Subject: Material for today's Light-duty GHG NPRM discussion.

Summary points from EPA review of CAFE model (NPRM version) – Effect of EPA code revisions

Meeting with Office of Management and Budget/OIRA

Figure 8 Cost and Effectiveness of MY2030 vehicles relative to a 'null' tech package (PEV's are off chart area, but included in fleet average)

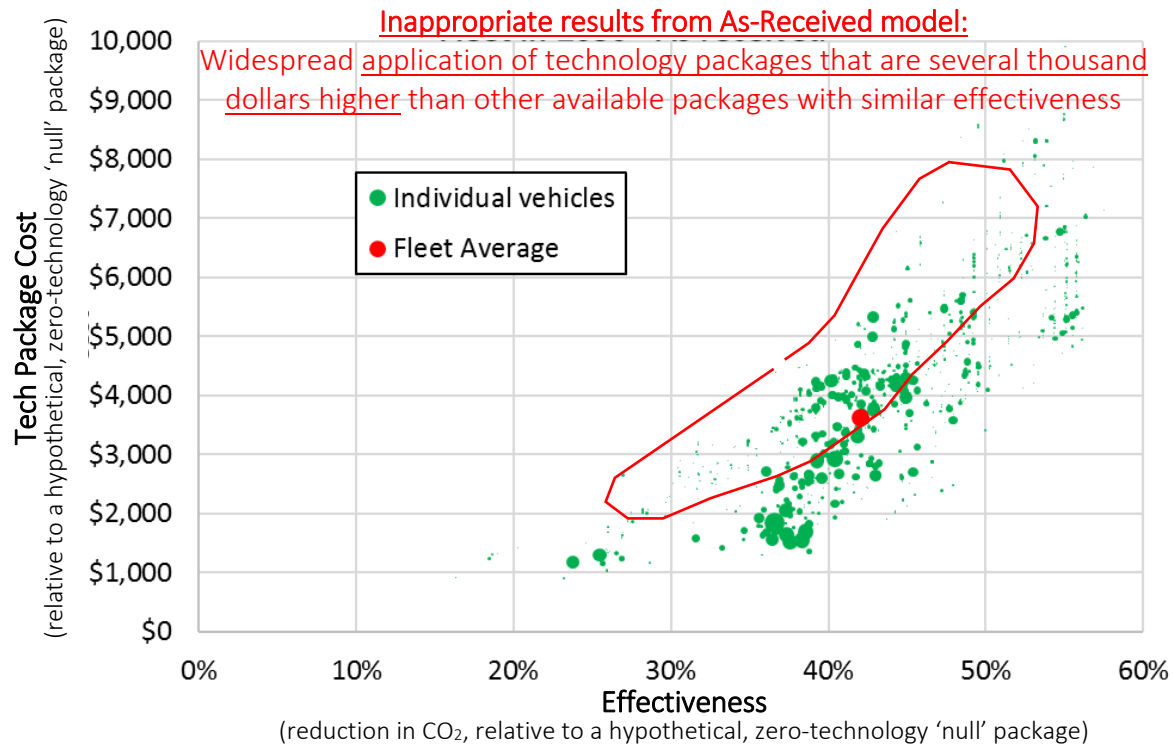
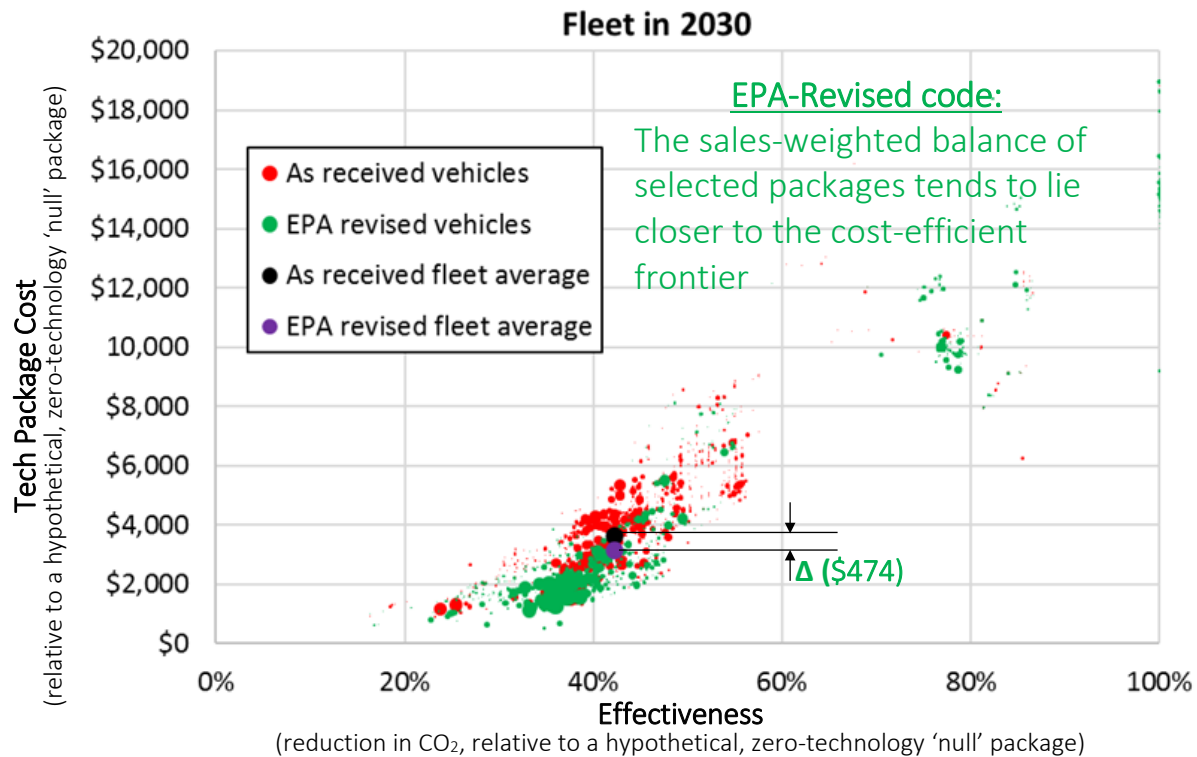
Figure 8 shows the total technology cost and effectiveness for all technology packages applied by the As-Received CAFE model to the MY2030 fleet, relative to a ‘null’ package with only basic technologies.¹² While we would not expect manufacturers to consistently apply technology packages that lie exactly on the cost-efficient ‘frontier’, the frequency with which the As-Received CAFE model applies packages that are several thousand dollars more expensive than other available packages is striking.

To resolve the issue of the cost-ineffective technology application decisions, EPA revised two elements of the CAFE model code. First, we revised “efficiency” calculation used for package ranking. Because we don’t believe that the value of a CO₂ credit to any manufacturer can be reasonably determined in advance¹⁴, we have removed the monetary valuation of CO₂ credits from the numerator of Equation 3, and instead include the change in quantity of compliance credits (in grams CO₂) as a normalizing factor in the denominator of the efficiency calculation. The modified calculation, shown as Equation 6, can be interpreted as the cost-efficiency of a technology application in terms of the net cost per gram CO₂ credits earned. We think that this decision rule would reasonably represent a manufacturer that is applying technologies in a cost-minimizing manner, subject to all the original constraints on technology availability and redesign cycles specified in the As-Received CAFE model input files. As with the As-Received CAFE model logic, our revised code prioritizes technology packages with more negative efficiency values.

Figure 16 EPA Revised Code Effects, Compare to As-Received CAFE model results in Figure 8
“Cost and Effectiveness of MY2030 vehicles relative to a ‘null’ tech package”

Figure 9 CO₂ Credit Value, by Model Year, as defined in As-Received CAFE model inputs

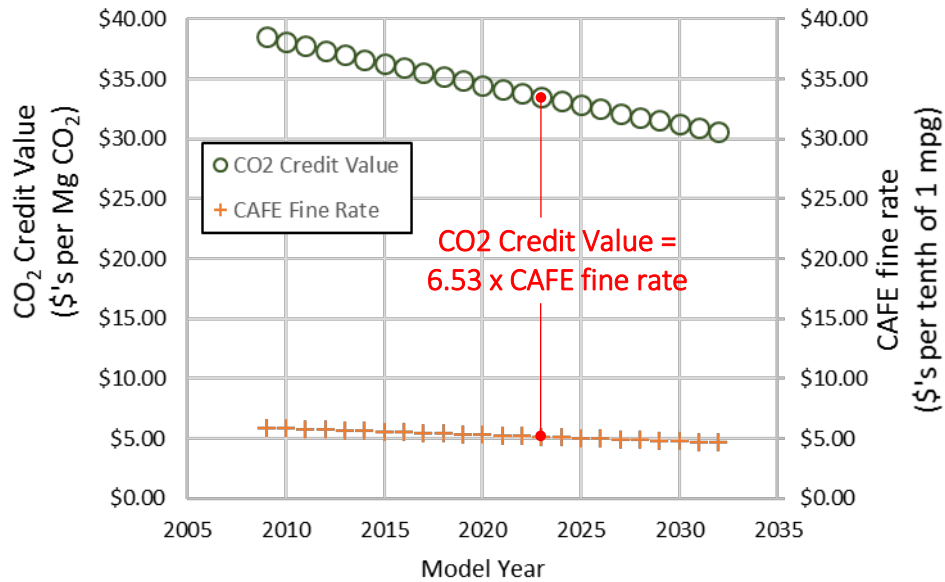
Figure 9 shows the CO₂ Credit Values by Model Year, which are defined in CAFE model input files using a simple scaling of the CAFE fine rates by a constant factor of 6.53. While the application of a uniform credit value is problematic given all the potential variations among manufacturers, it is probably even more problematic that the CO₂ value is assumed to be decreasing over time. Given that the GHG program does not allow manufacturers to pay fines as a compliance strategy, we assume that NHTSA's intent was for the CO₂ credit value to represent a market value for trading credits between manufacturers. Regardless of the intent, as the adoption of the lower-cost technologies leaves only the more expensive alternatives available to meet future year stringency increases, it is implausible that the value of CO₂ credits to a manufacturer will decrease in this way over time.

Figure 10 Effect of truncating CO₂ credit value in CAFE model's 'efficiency' calculation for tech package selection
Assuming \$3/gal fuel price, \$35/MgCO₂ credit value, and 30k miles driving in first 2.5 years (for consumer payback)

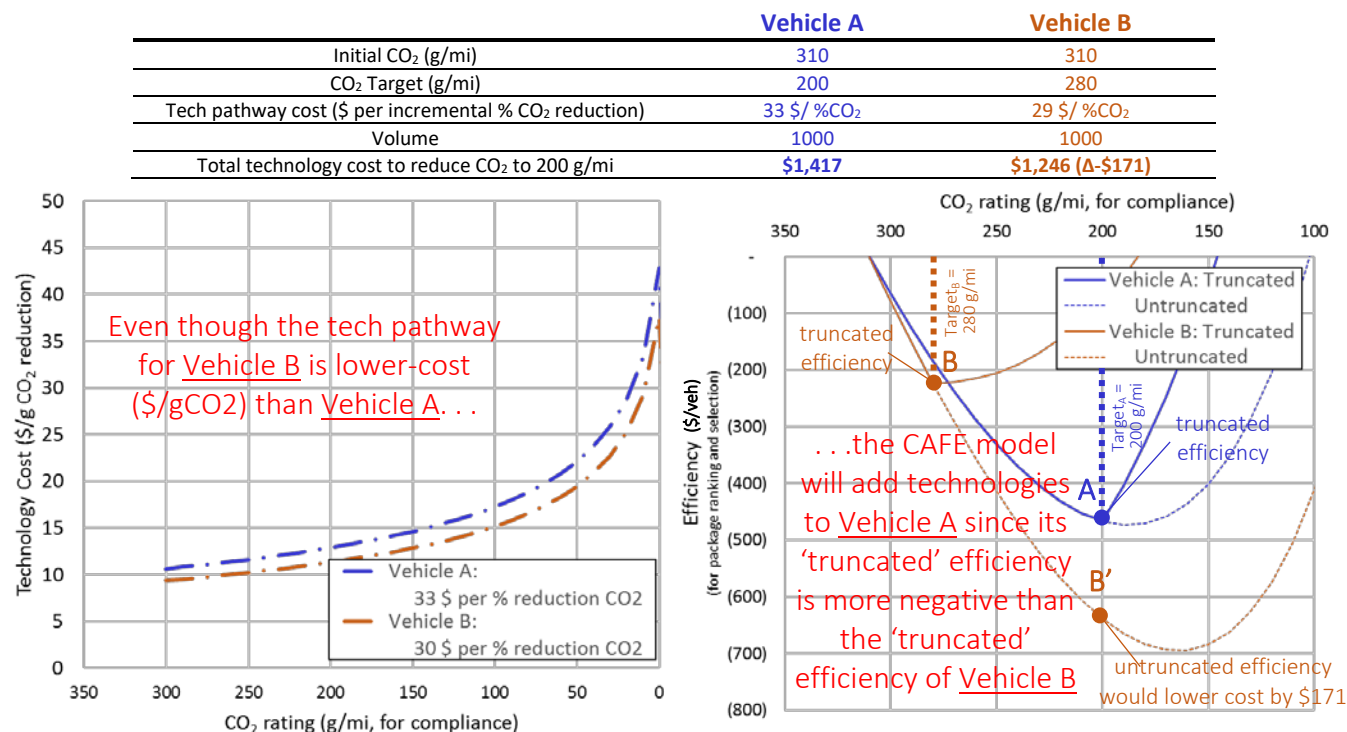
as shown in Figure 10, since the credit value for reducing Vehicle B below its 280 g/mi target is truncated and not included in the efficiency calculation. The CAFE model will choose to apply technology to Vehicle A to reduce CO₂ to 200 g/mi, even though that technology pathway is less cost effective than one where technology is applied to Vehicle B (point B' in Figure 10) – with a technology cost of \$1,417 for Vehicle A compared to \$1,246 for Vehicle B for the same CO₂ reduction.

Figure 18 EPA Revised Code Effects, Compare to As-Received CAFE model results in Figure 11
“MY2030 Required and Achieved CO₂ levels for Each manufacturers regulatory car and truck fleets”

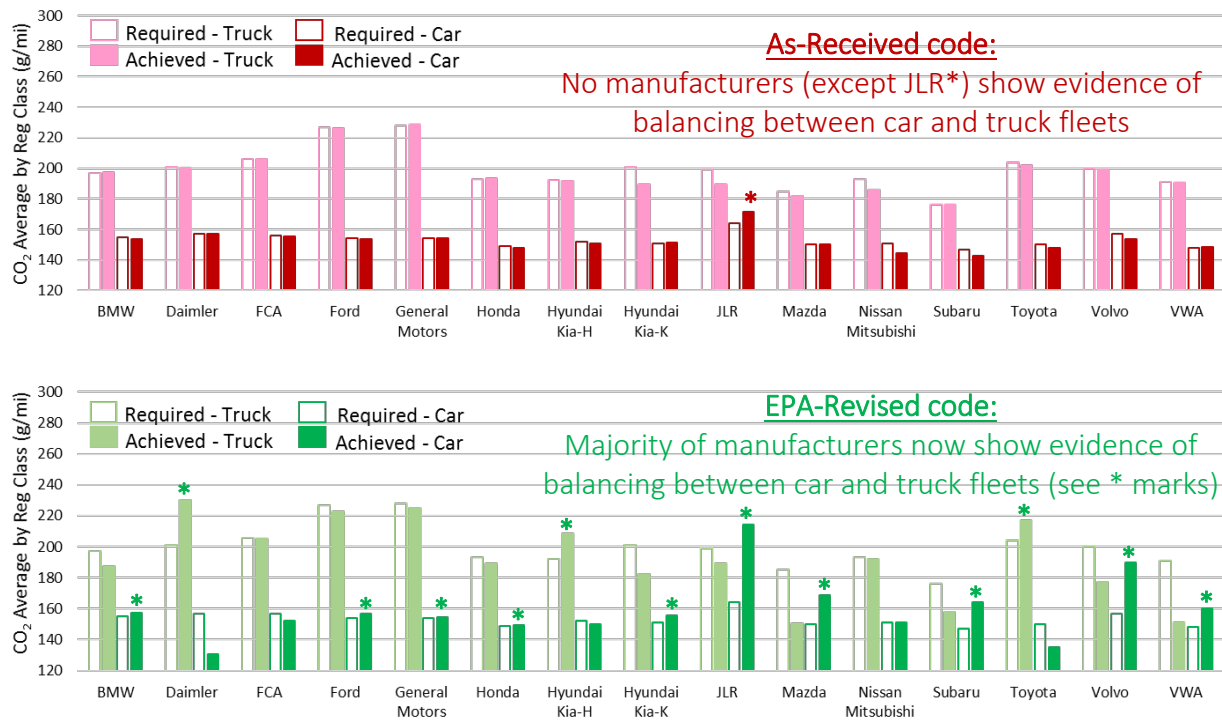
The third factor that contributes to the CAFE model's application of cost-inefficient packages is the separate treatment of regulatory classes when determining compliance status. Figure 11 below shows that with only one exception,¹³ the achieved CO₂ levels for the regulatory car and truck fleets for all manufacturers in MY2030 is below the required CO₂ level. This result is striking, not only in the consistency of overcompliance, but also in the apparent lack of balancing within a manufacturer between car and truck regulatory fleets. A more realistic modelling representation would tend to show some overcompliance in one regulatory fleet, offset by undercompliance in the other fleet as the manufacturer seeks to reduce compliance costs by applying technology to reduce emissions where it is most cost-effective.

The second change in the EPA-Revised code involves the lack of credit transfers between regulatory classes. As shown in Equation 7, we now set each manufacturer’s ‘in compliance’ flag based on the

Figure 1 Incremental Effectiveness of TURBO1 to TURBO2 (MedSUV class)

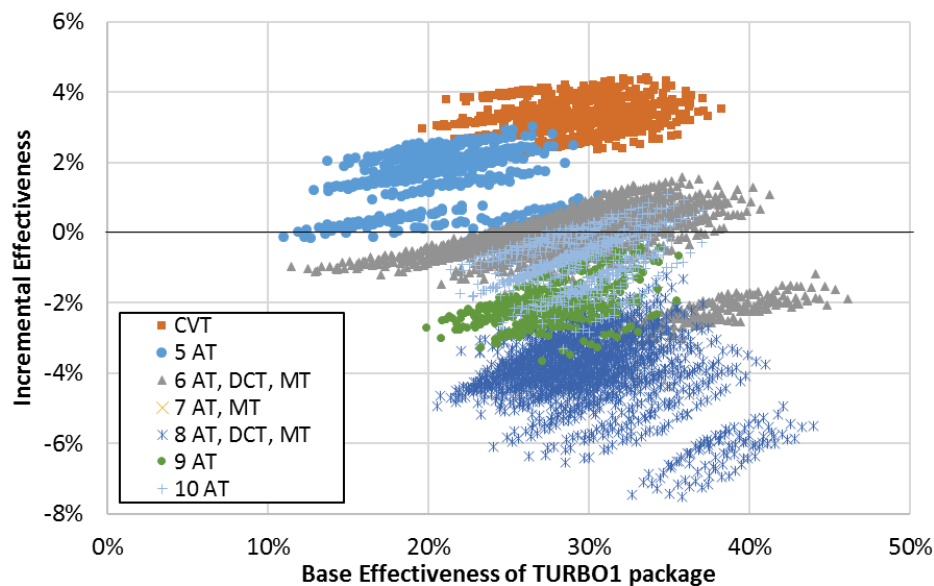
The technology inputs include two levels of turbocharged engines, TURBO1 and TURBO2. The incremental cost of TURBO2 hardware over TURBO1 hardware is about \$350 to \$700 in 2030; although it is unclear what specific technologies are represented by this cost, one would expect a generally higher effectiveness. However, depending on the package and car class, the actual incremental effectiveness values from the NHTSA technology inputs for the TURBO2 technology is often negative. The “Medium SUV” class, shown in Figure 1 has the most pronounced effect, **with the addition of the TURBO2 technology, on average, having a negative effectiveness.**

Figure 2 Incremental Effectiveness of TURBO2 to CEGR1 (MedCarPerf class)

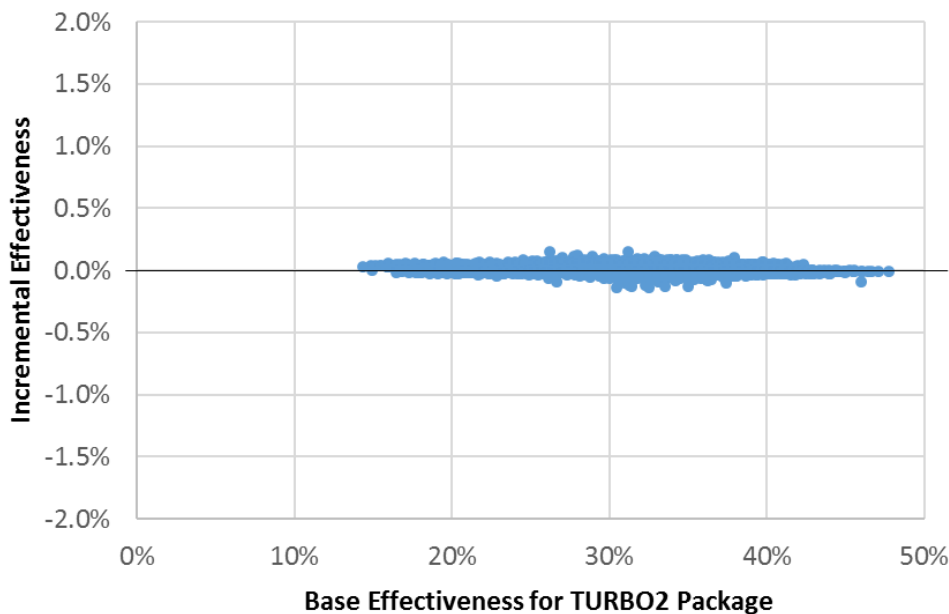
Observation 3: *The addition of cooled exhaust gas recirculation (CEGR1) onto turbocharged engines (TURBO2) provides no relative benefit, despite the additional cost of the technology. Given this input assumption, the CAFE model outputs, as expected, do not show application of CEGR1.*

A cooled EGR package when added to the advanced turbocharged engine (TURBO2) has a cost of \$334 in 2030. Cooled EGR is a technology that has been used in the market, and has a significant effect on CO₂ reduction. However, as illustrated in Figure 2, the incremental effectiveness is at or near zero for EPA findings on initial review of NHTSA Jan-22, 2018 CAFE model runs (final version for 2/12/2018 NHTSA briefing)

Figure 3 Incremental Effectiveness of the best six-speed (AT6L2) v. the best eight-speed (AT8L3) (Small SUV)

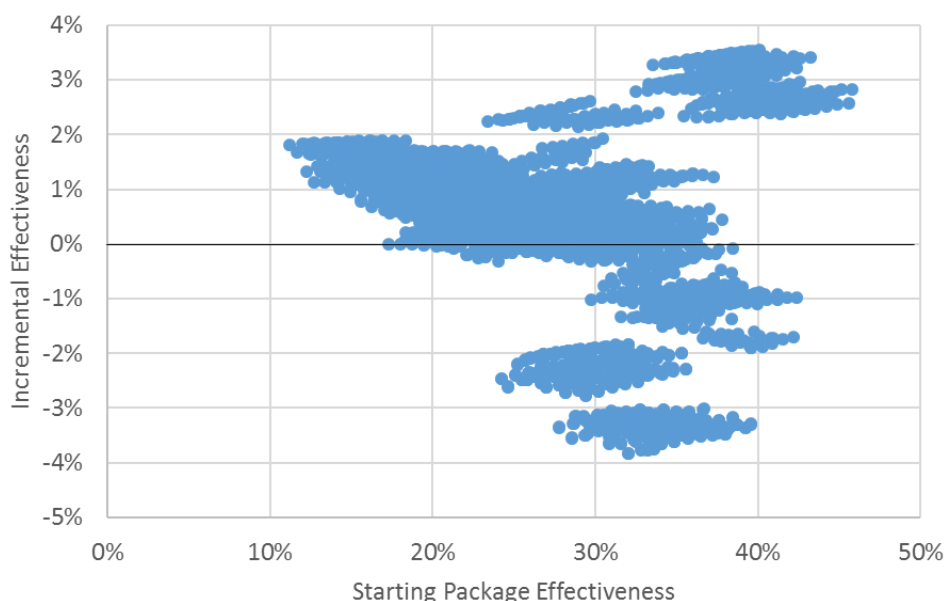
The modeled automatic transmissions include one “improved” level of a six-speed automatic (AT6L2) and two improved levels of eight-speed automatics (AT8L2 and AT8L3). The cost of the AT6L2 package (additional to an AT6) is \$362 in 2030. The cost of the AT8L3 package (additional to an AT8) in 2030 is nearly the same (\$358). Incremental to the AT6, the best eight-speed package is \$485 (i.e., \$123 more than the AT6L2). However, on average, the technology inputs provided show that the AT8L3 is only 1% more effective than the AT6L2, and in some cases is worse (as shown by the Small SUV plot).

Figure 4 Incremental Effectiveness of six-speed (6AT) to eight-speed (8AT) for Pickup and Medium Car

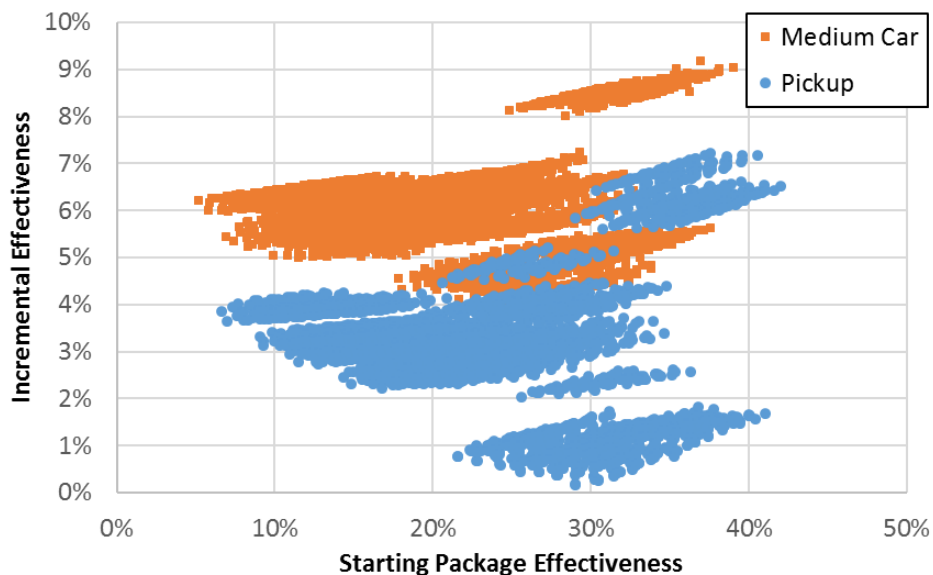
The technology inputs provided seem to show that the incremental effectiveness associated with moving from a six-speed transmission (AT6) to an eight-speed transmissions (AT8) is noticeably different depending on class. The figure shows effectiveness for a medium car and a pickup; on average, the eight-speed effectiveness for the car is about twice that for the truck. This trend seems to hold for the small and medium car classes, which have AT8 effectiveness about twice that of the medium SUVs and trucks (with the small SUVs in between). This may be due to assumptions about front-and rear-wheel drive systems; however, comments from stakeholders have indicated that RWD systems should have greater potential for transmission effectiveness improvements, as packaging more gears in the space provided is less of a concern.

Figure 5 Incremental Effectiveness of 48V Mild Hybrid with belt-integrated starter-generator (BISG) to crank-integrated starter-generator (CISG) (Small Car class)

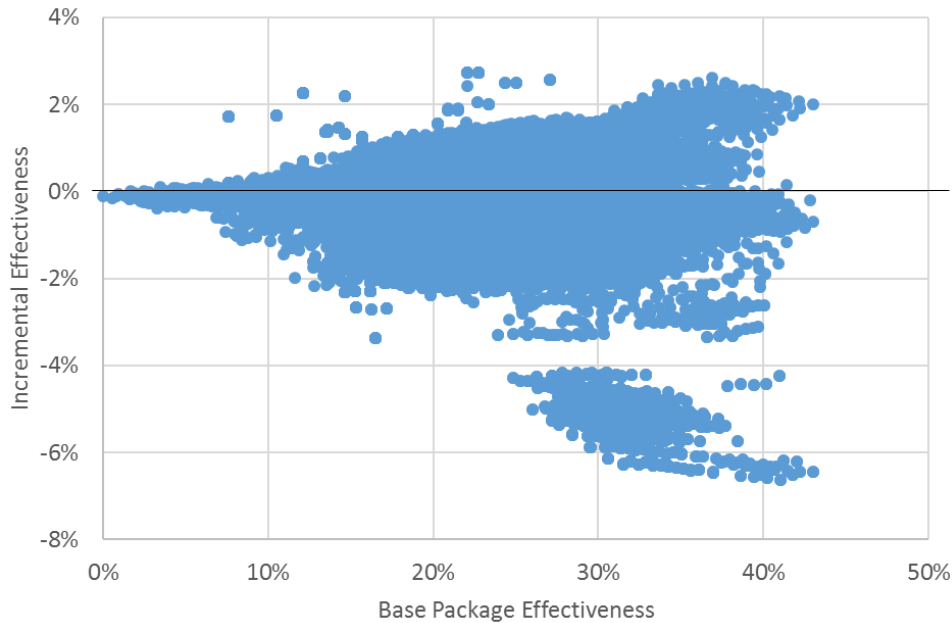
The cost of a crank-integrated starter-generator (CISG) system in 2030 is given as either \$178 (for smaller vehicles) or \$767 (for larger vehicles) in 2030, incremental to a belt-integrated starter-generator (BISG). Additional battery costs in 2030 are about \$617 for the BISG and \$805 for the CISG, making the incremental CISG battery cost an additional \$187. The CISG is expected to provide additional effectiveness over the BISG because of the direct couple to the crank.

However, on average, the CISG is slightly less effective than the BISG, although with a wide spread of effectiveness. The small car example shown in Figure 5 is typical, with the incremental effectiveness of most packages between about +1% and -1%.

Figure 6 Incremental Effectiveness of CONV to SS12V for Small Car class (left) and Medium SUV Perf class (right)

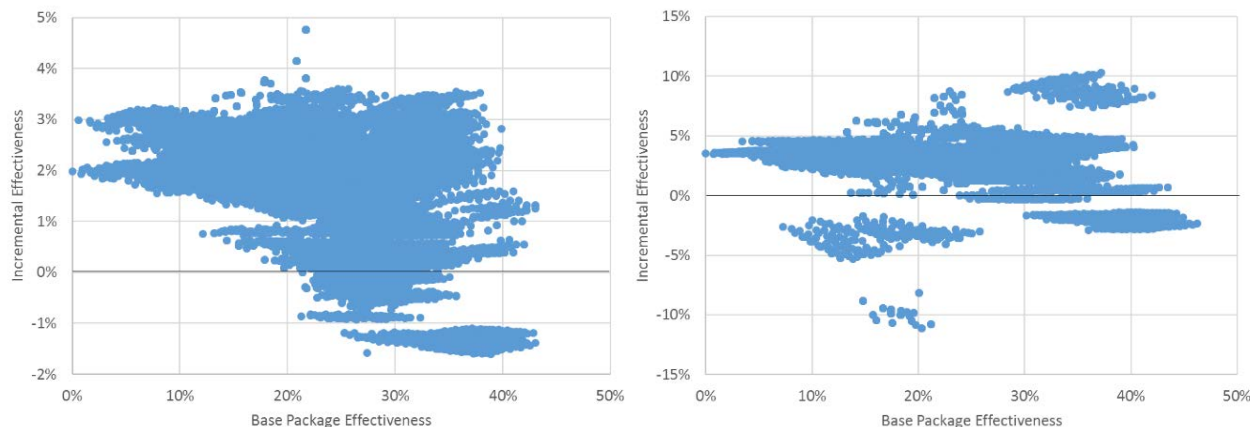
The cost of stop-start technology is either \$466 or \$521 in 2030, depending on vehicle class, plus about \$582 in battery costs. However, there are some packages where the provided technology inputs indicate a negative effectiveness, as shown in Figure 6 for the small car class below. Moreover, there are a few packages in some classes that are clear outliers (see the medium SUV performance class), **either high or low.**

Figure 8 Comparison of NHTSA mileage accumulation schedule with data from other sources for cars (left) and trucks (right)

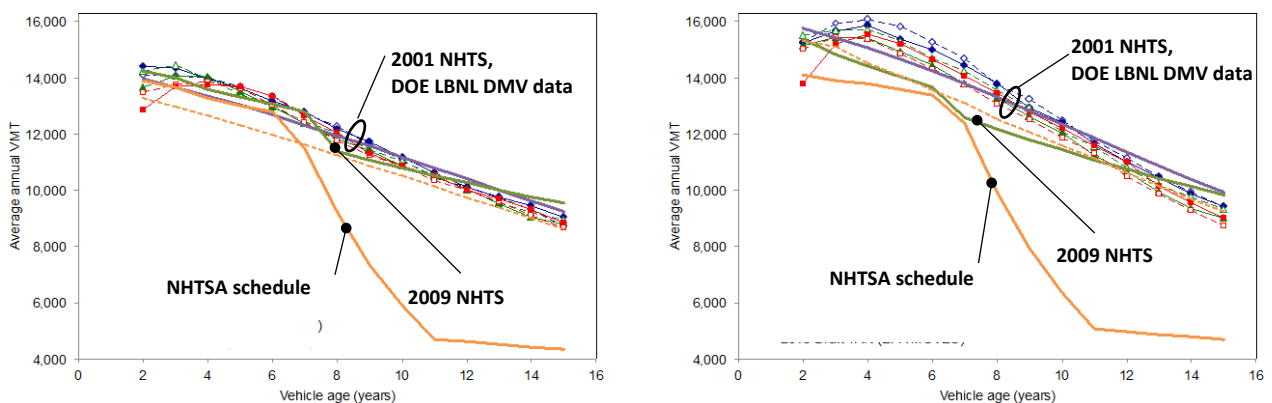
The table of vehicle miles traveled (VMT) by vehicle age described in the ‘parameters’ input file shows a steep drop-off in annual VMT after age 6. NHTSA had first utilized a curve with that shape in the 2016 Draft TAR, and EPA understands the underlying data source is an IHS/Polk product based on odometer readings from individual vehicles. The drop-off in annual VMT in the NHTSA schedule shown in Figure 8 is not seen in other data sources, including the 2001 National Household Travel Survey (NHTS), and a DOE LBNL analysis based on odometer readings from DMV records of the Texas inspection and maintenance program. The 2009 NHTS data shows a decline that coincides with the NHTSA schedule, but of a much smaller magnitude.

Figure 5 Fixed Effect Values used in the Safety Analysis

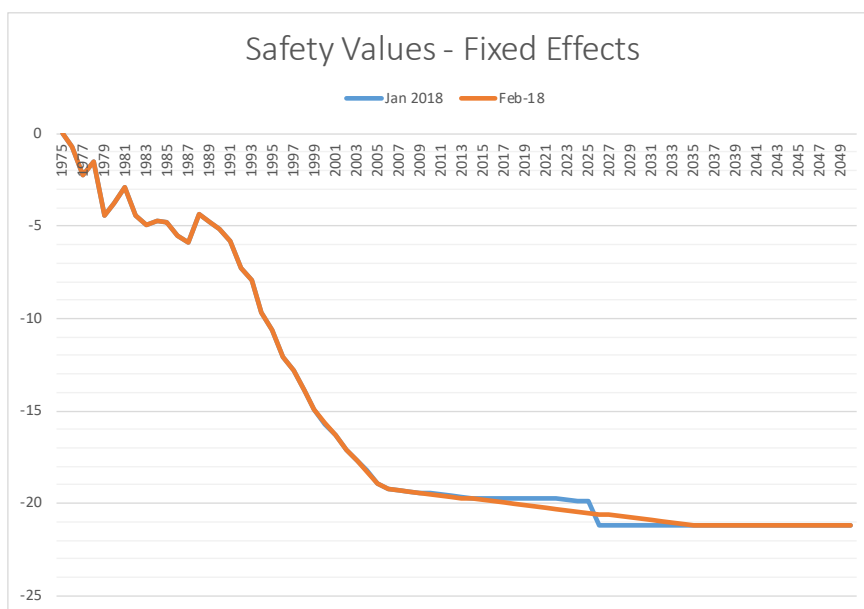
EPA’s initial observation with regard to the safety values in Figure 7 are noted above. Since that time NHTSA has modified the data and provided a brief description of how the revised curve was created. NHTSA explained that the curve was developed in consideration of future NHTSA safety regulations and the belief that manufacturers would improve the safety of their vehicles of their own volition. In addition, NHTSA explained that the majority of the increased fatalities associated with older vehicles is the result of driver demographics and use. For example, older vehicles which are involved in fatalities also tend to be operated under the influence of alcohol. EPA has requested a full explanation of how this curve was developed, including both the quantitative estimates of safety improvements due to regulation and the subjective estimates of safety improvements.
